September 15, 2010

Attn: Document Control Desk
Ron Linton
Project Manager
Uranium Recovery Licensing Branch
Division of Waste Management and
Environmental Protection
Office of Federal and State Materials and
Environmental Management Programs
U.S. Nuclear Regulatory Commission
Two White Flint North, MS T8F5
11545 Rockville Pike
Rockville, MD 20852

Re: Text Revisions to the Open Issues to the Safety Evaluation Report for the Nichols Ranch ISR
Project License Application (TAC J00553, Docket No 040-09067)

FIGURE D6C.7-1 BAROMETRIC PRESSURE AND WATER-LEVEL CHANGE IN F SAND PUMPING WELL, URZHF14

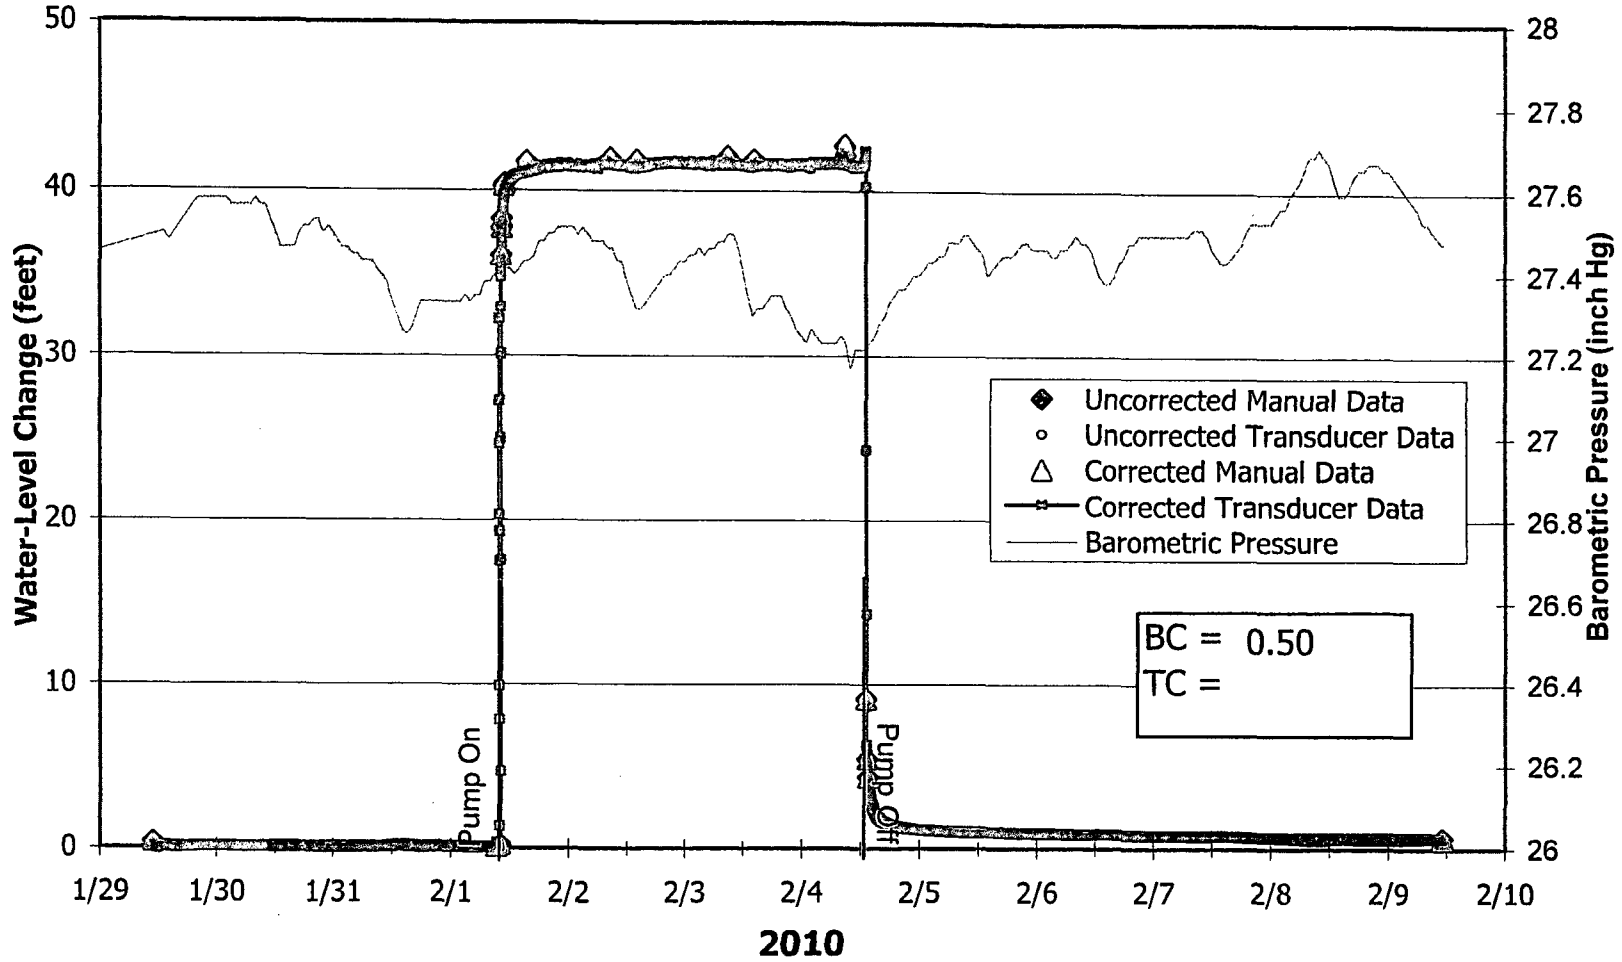
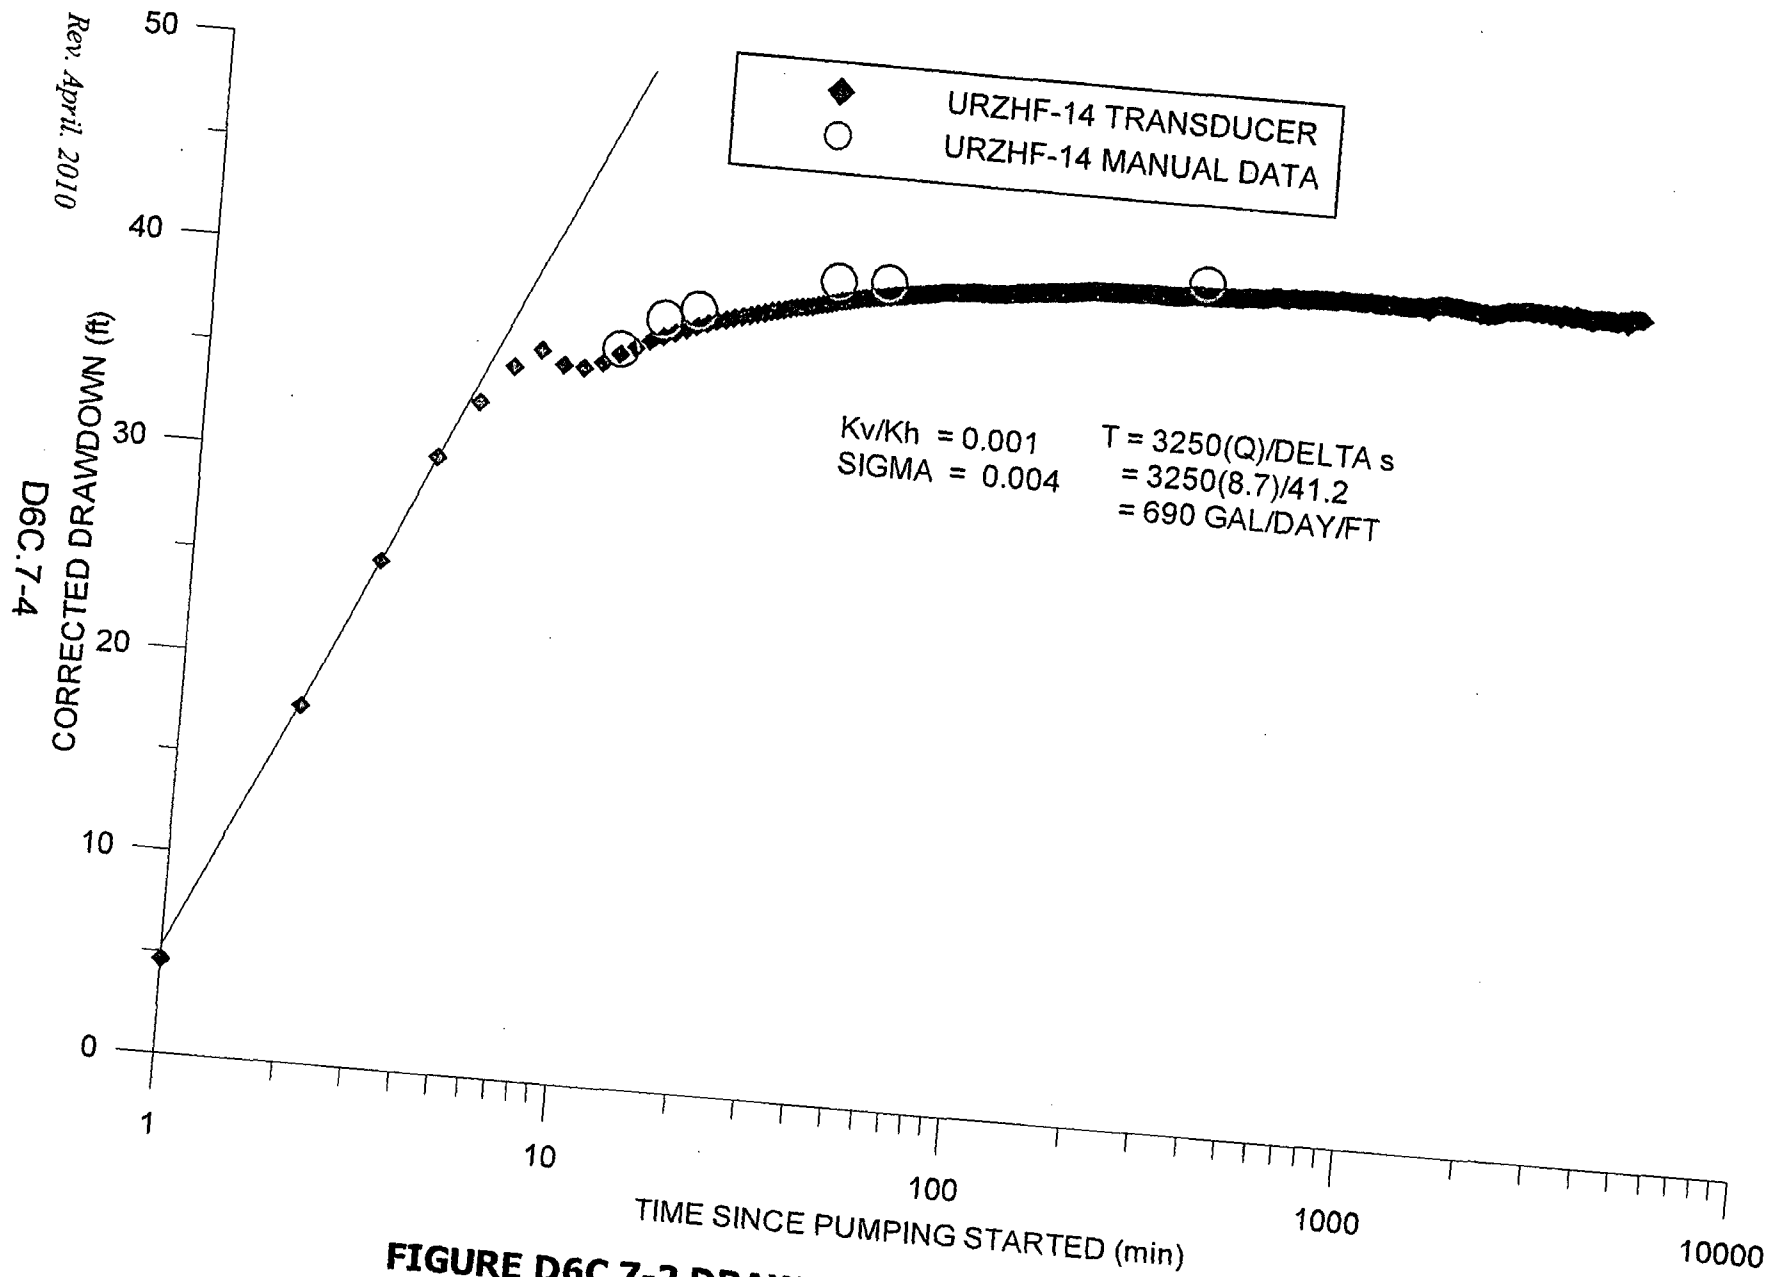
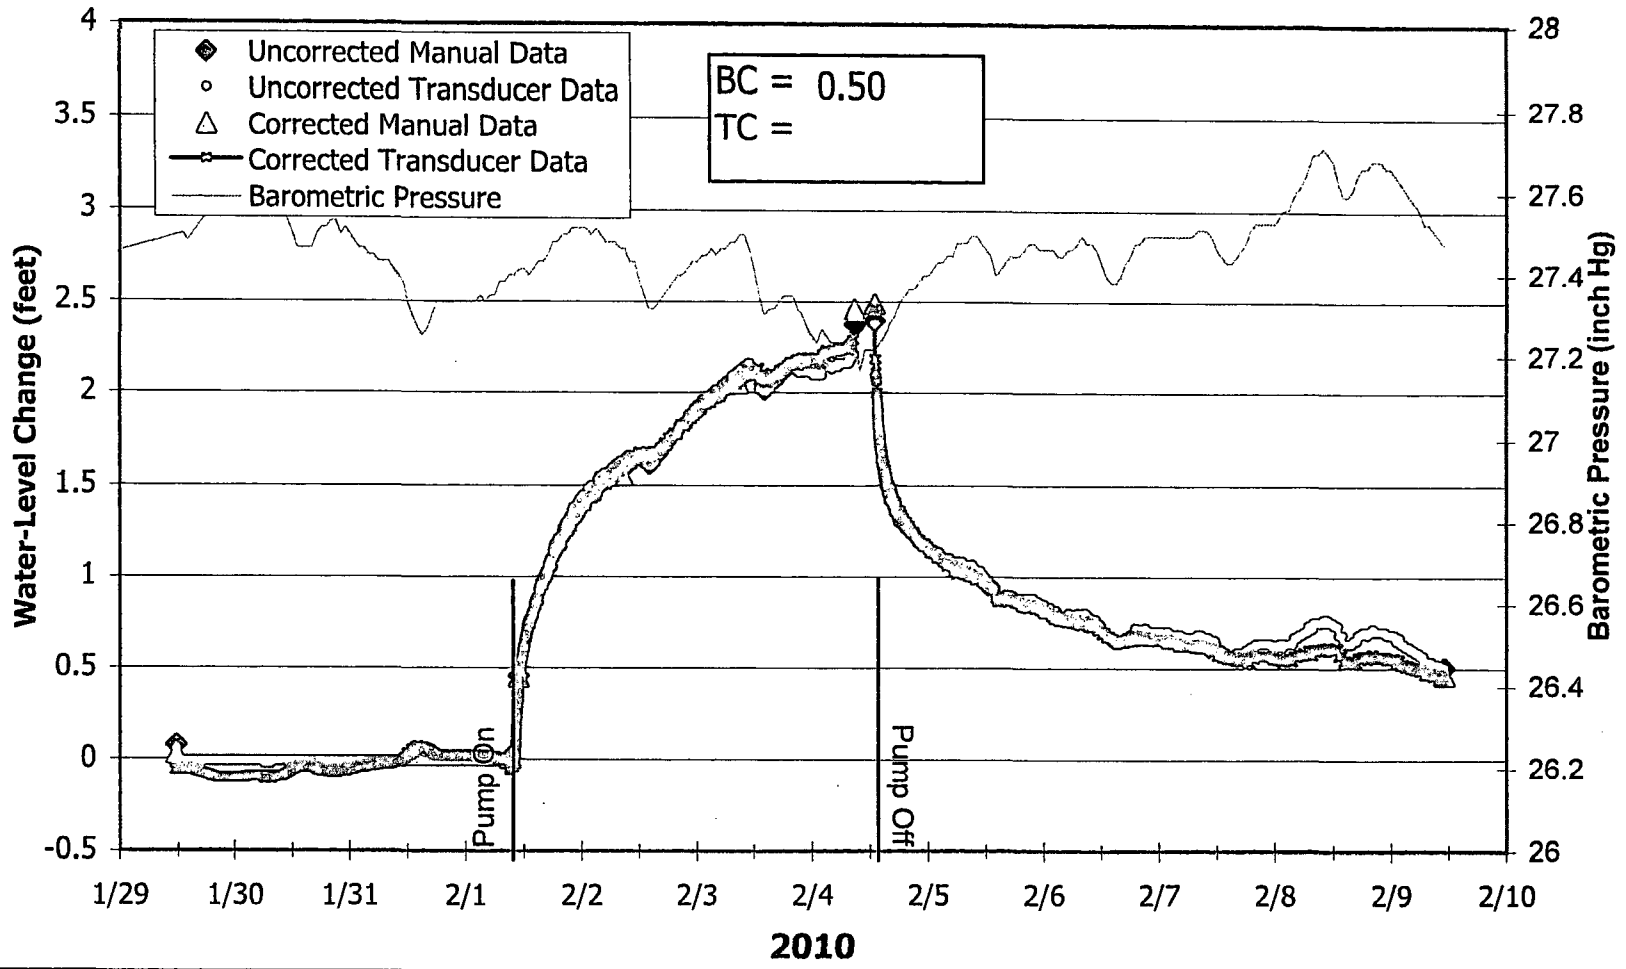
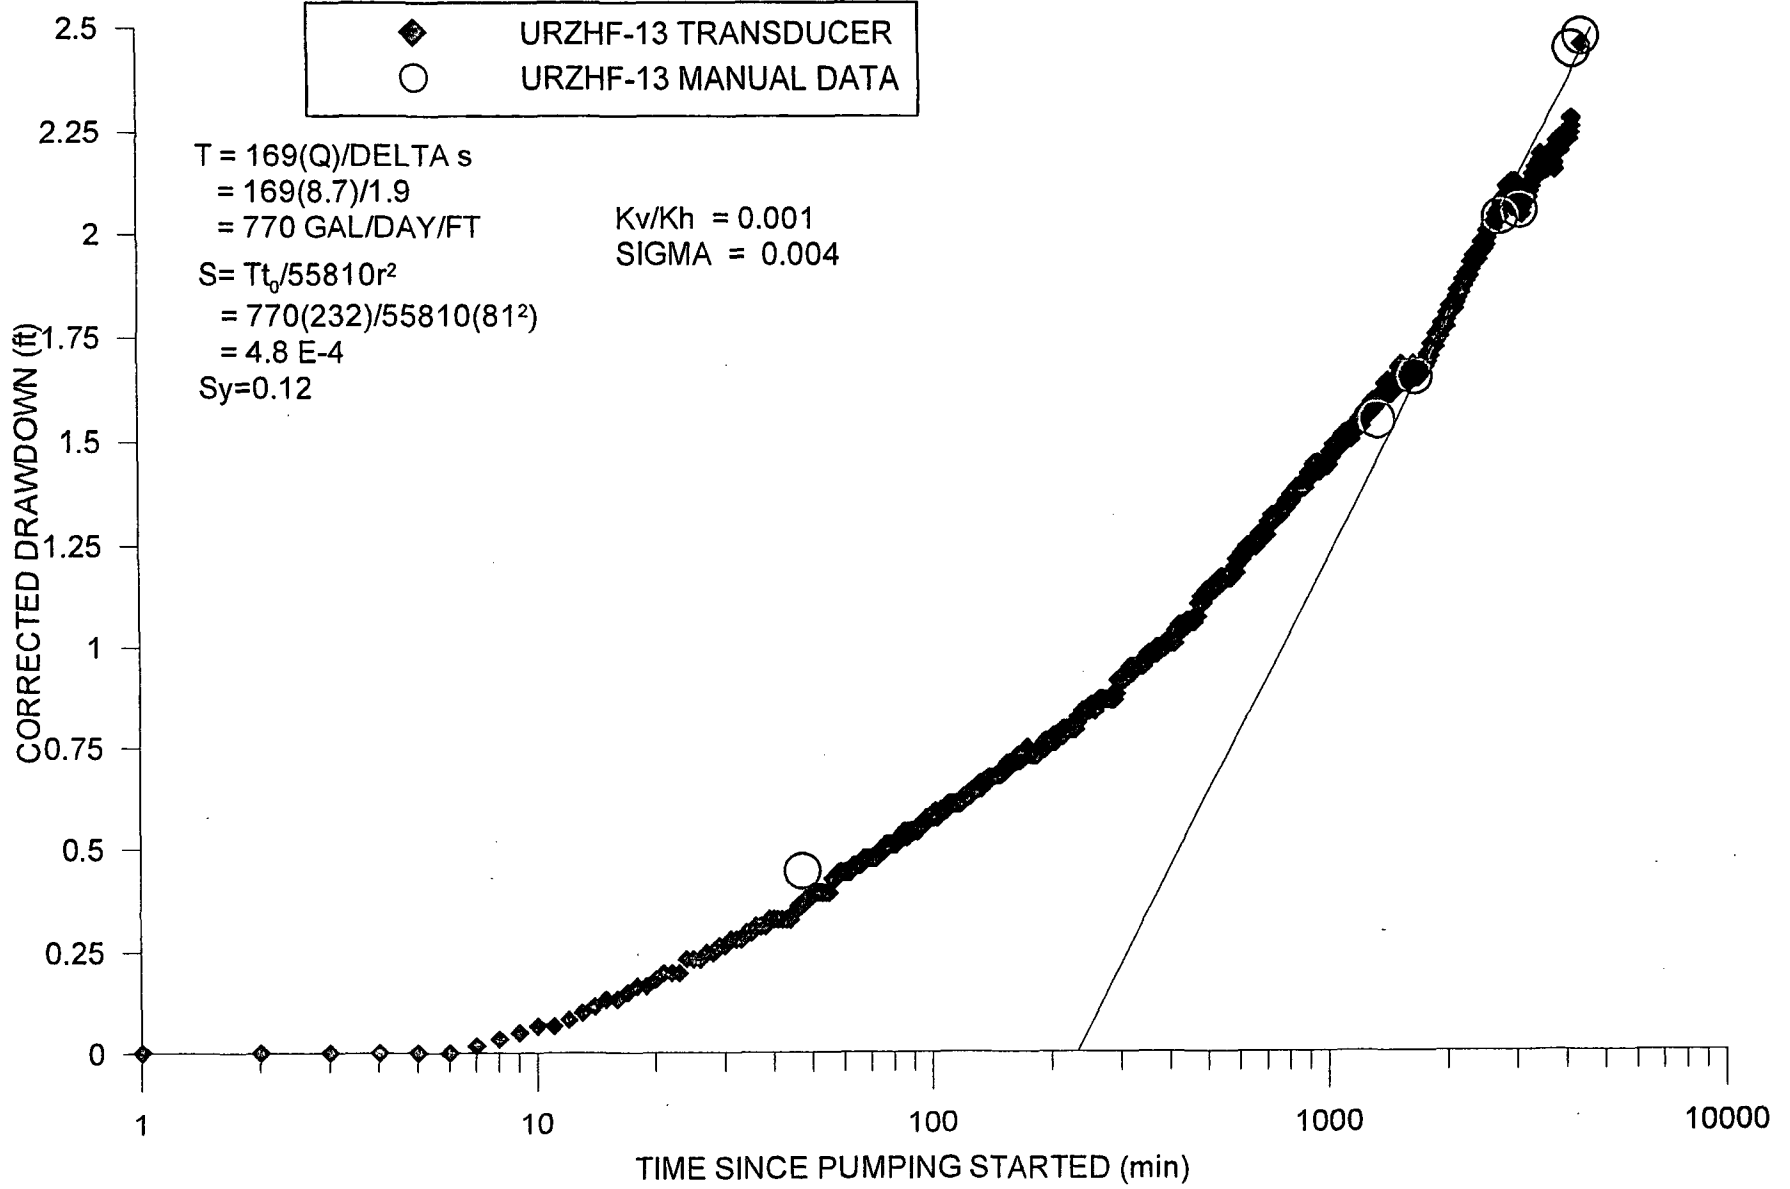
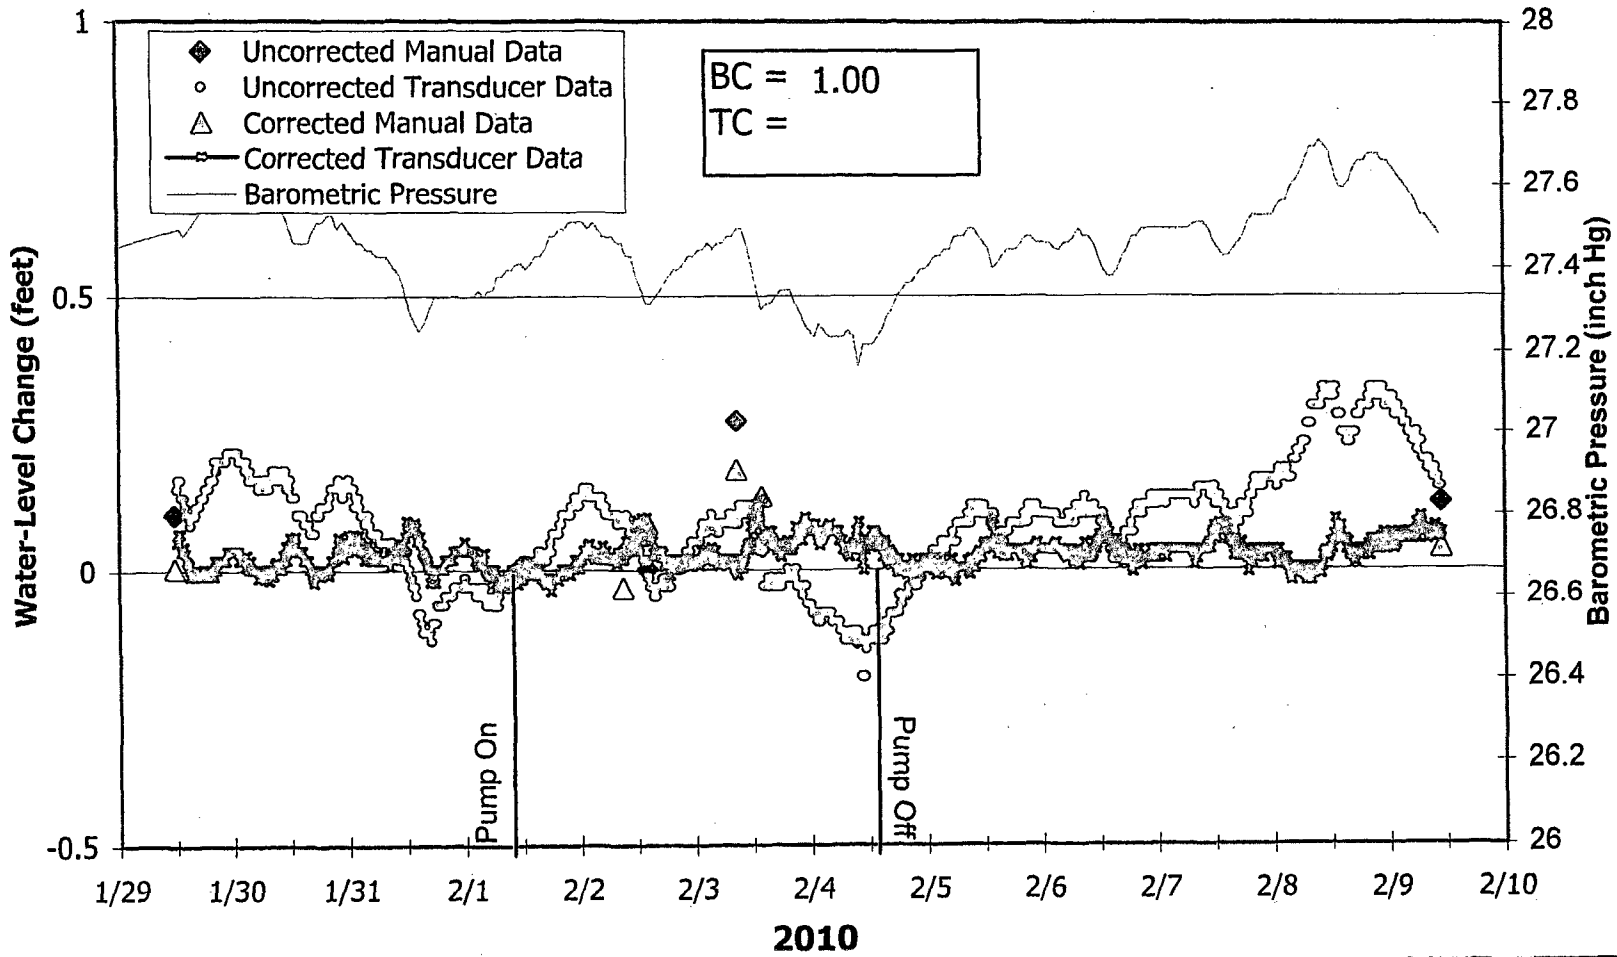
Volume VI, Appendix D6, Addendum D6C		Figures D6C.7-1 through D6C.7-5, April 2010, pgs D6C.7-3 through D6C.7-7	Figures added per Third Consolidated Review Comment 116-M.
Volume VI, Appendix D6, Addendum D6C		Tables D6C.7-1 through D6C.7-6, April 2010, pgs D6C.7-8 through D6C.7-24	Tables added per Third Consolidated Review Comment 116-M.
